Summary of relevant changes in manuscript version 3

Reply to Reviewer 1 comments

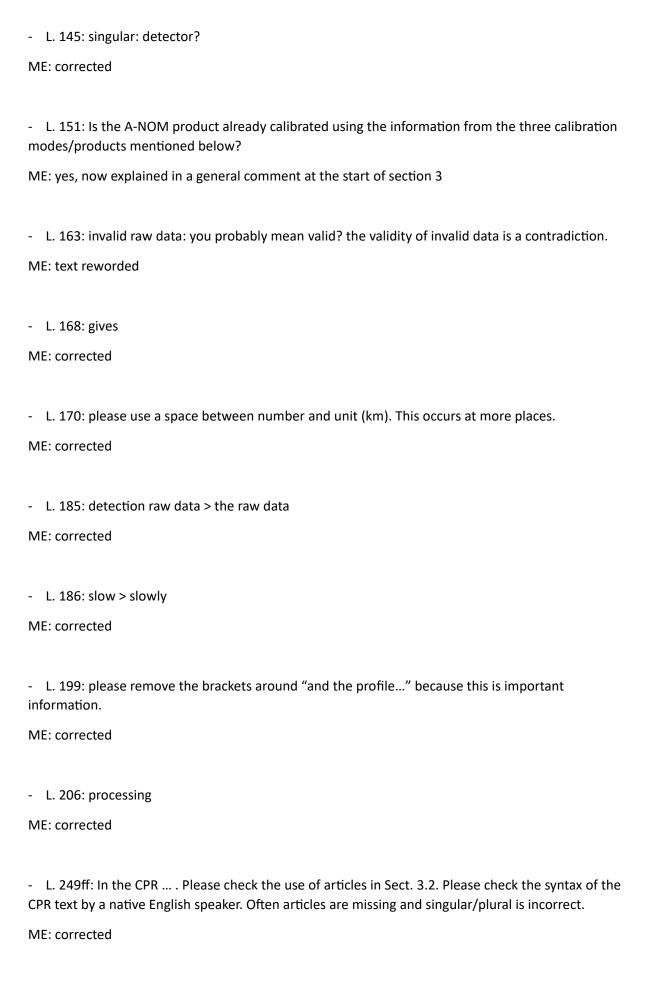
- L. 127: What about the effects of the instrument optics?

- The entire paragraph from I. 125 to I. 130 about the signals and the optical chain is unclear. Please avoid using text between brackets, and reformulate the text with clear sentences. It could help to add an equation to explain the ATLID signal and its data processing.

ME: Paragraph completely rewritten, and equation added

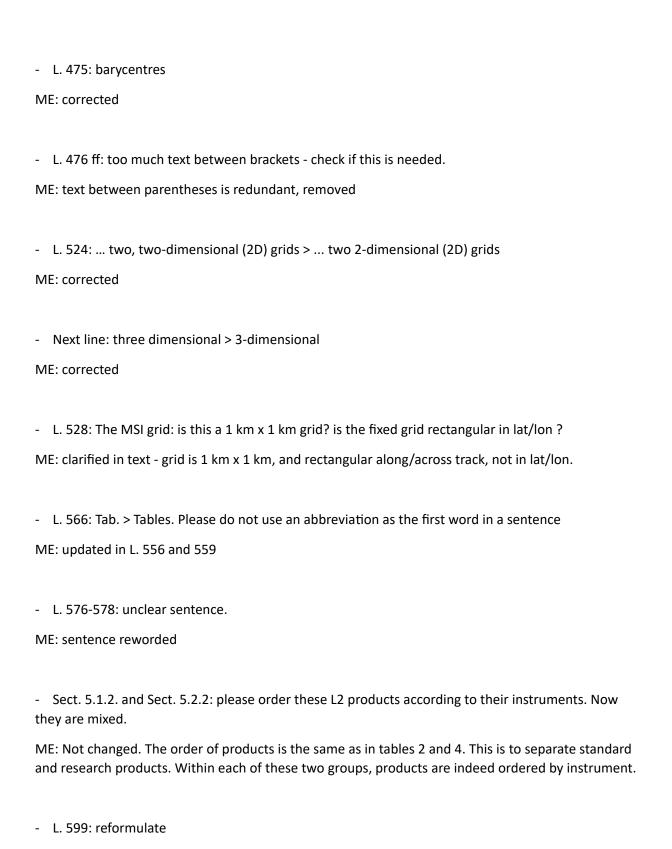
- L. 464: explain BB

ME: spelled out

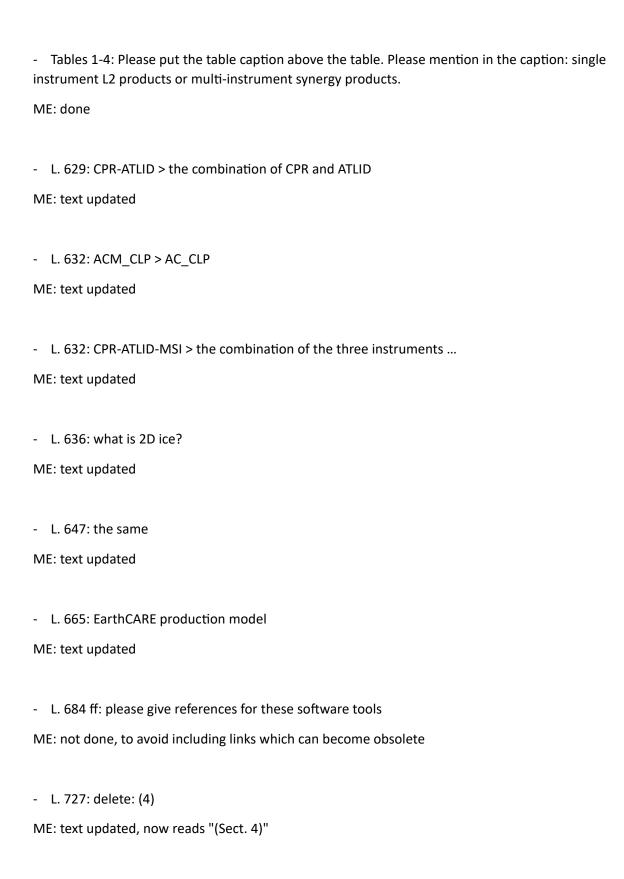
- Table 1: This does not look like a logical ordering of products. Same comment for the other tables.

ME: Not changed. Products are grouped by instrument, then processor, following the production model left to right, and top to bottom, i.e., products produced first are listed first.
